Title: Advisory Committee on Reactor Safeguards  
608th Meeting

Date: Wednesday, October 2, 2013

ADVISORY COMMITTEE ON REACTOR SAFEGUARDS  
(ACRS)

**Figure VII-1**  
**One of the Pool Layouts Modeled in NRC's Draft Consequence Study: The OCP2, High-Density, 1x4 Case**

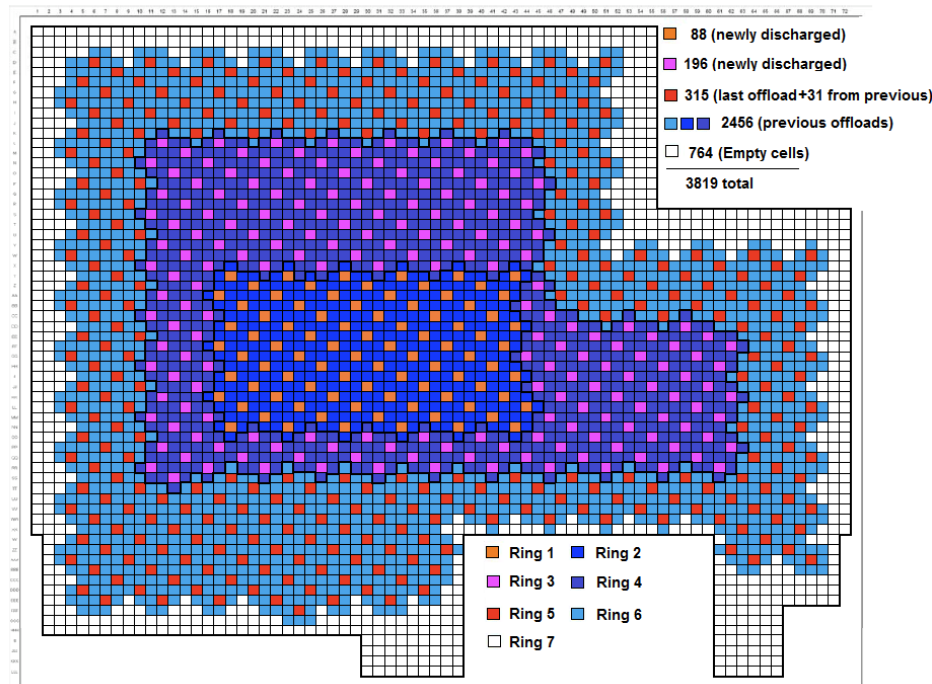
(VII-5) In addition to questions about the validity of MELCOR, there are questions about NRC's input assumptions. For example, how closely does the pool layout shown in Figure VII-1 correspond with actual practice in the nuclear industry? In that context, there is a puzzling NRC assumption associated with Figure VII-1. That figure shows a total of 284 newly-discharged fuel assemblies. Of these, 88 assemblies are assumed by NRC to produce decay heat at the rate of 10.9 kW per assembly when aged 20 days, while the remaining 196 assemblies produce 6.6 kW per assembly at the same age.<sup>47</sup> If this is typical practice, then licensees are forgoing substantial available burnup of the

majority of their fuel assemblies, with a resulting economic penalty.<sup>48</sup> As a related matter, Figure VII-1 shows a rather elaborate layout of fuel, whose achievement would involve substantial shuffling of assemblies. NRC says that this layout is comparatively favorable in terms of the risk of a pool fire. Yet, licensees are allowed a period of time, during and perhaps after a refueling outage, to perform the shuffling needed to achieve a favorable layout. The length of that period of time is a secret because, NRC says, this information could be useful to an adversary.<sup>49</sup> Thus, is it appropriate to assume, as a MELCOR input, that a comparatively favorable layout has been achieved before water is lost?

**Findings from NRC's Draft Consequence Study: Water Level and Ring 1 Cladding Temperature for Unmitigated High-Density Moderate Leak (OCP4)**

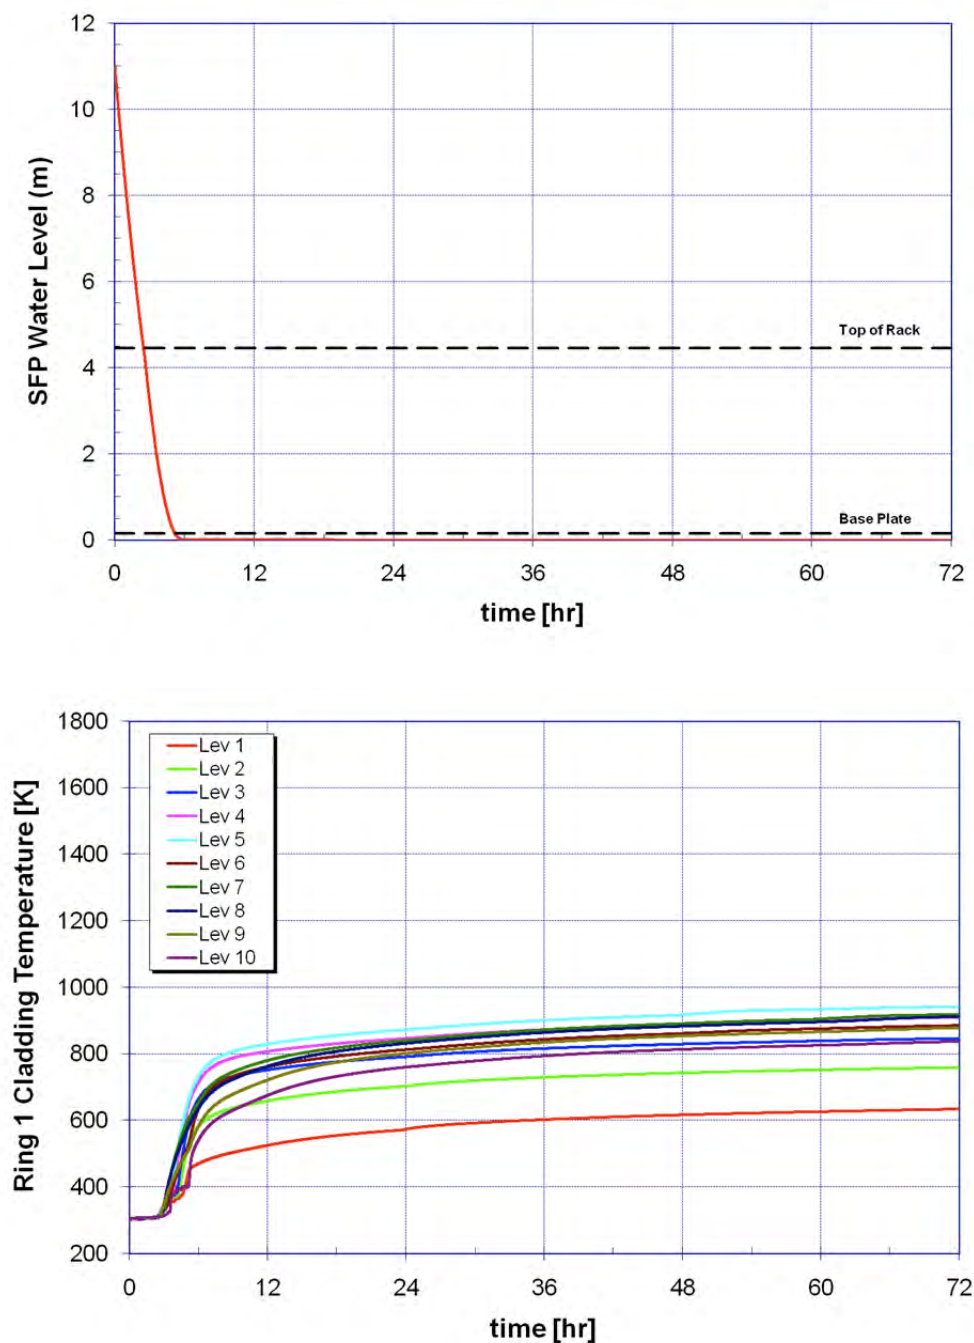
(VII-10) Now, consider MELCOR outputs for NRC's examination of a moderate-leakage case in OCP4, as shown in Figure VII-2. During the evolution of this case, there would be a period of time when the upper portion of the fuel is exposed and residual water is present. That period would extend from about  $t = 3$  hours to about  $t = 6$  hours. During that 3-hour period, at the "Lev 5" elevation of the fuel, cladding temperature would rise from about 300 K to about 700 K. Thus, the average rate of temperature rise would be about 130 K per hour. This finding indicates that the exposed portion of the fuel at the Lev 5 elevation would be in an approximately adiabatic situation, at least for temperatures up to 700 K.

**Findings from NRC's Draft Consequence Study: Water Level and Ring 1 Cladding Temperature for Unmitigated High-Density Small Leak (OCP4)**

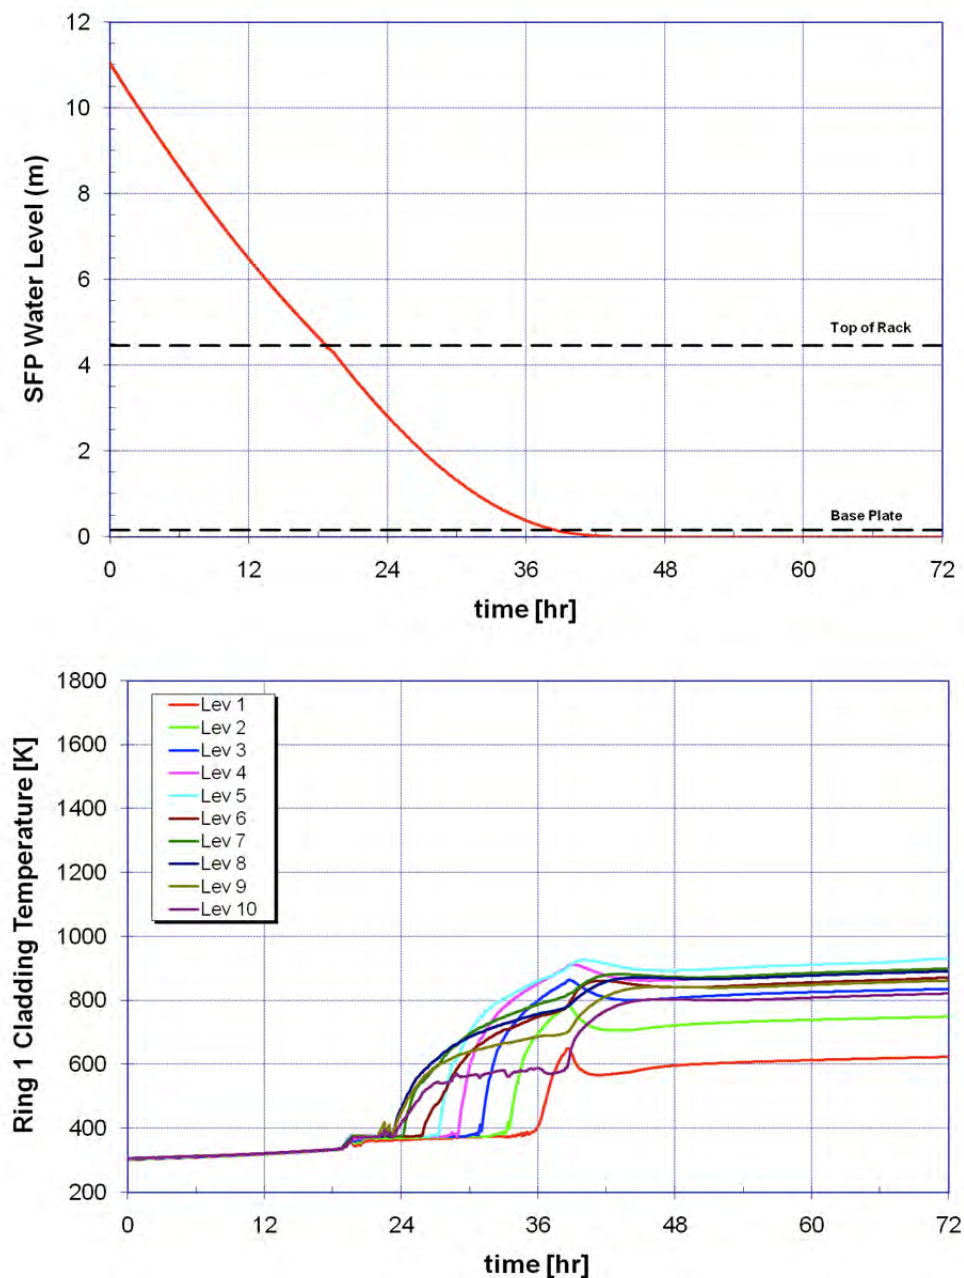
(VII-11) Now, apply the same process, as in the preceding paragraph, to NRC's examination of a small-leakage case as shown in Figure VII-3. In that case, the period of time when fuel at the Lev 5 elevation is exposed and residual water is present would extend from about  $t = 28$  hours to about  $t = 40$  hours. During that 12-hour period, the temperature of fuel cladding at the Lev 5 elevation would rise from about 350 K to about 900 K. Thus, the average rate of temperature rise would be about 46 K per hour.
